**THM 4L80-E/4L80-EHD  
NEW DESIGN FOURTH AND  
OVERRUN CLUTCH STEEL PLATES**

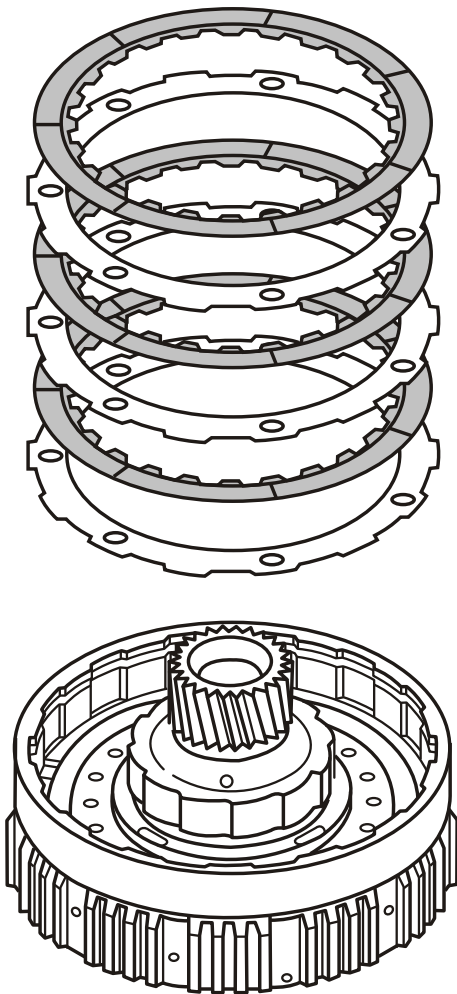
**CHANGE:** Beginning at the start of production for all 1997 model THM 4L80-E transmissions were built with new design steel plates for both the fourth clutch and the overrun clutch, which now include "Turbulator" holes in the plates (See Figure 1).

**REASON:** The holes interrupt fluid surface pressure to improve efficiency.

- (1) OVERRUN STEEL PLATES - New design has seven holes in the steel plates (See Figure 1).
- (2) 4TH CLUTCH STEEL PLATES - New design has four holes in steel plates (See Figure 1).

The new design steel plates are not recommended for previous models because of calibration considerations and changes.
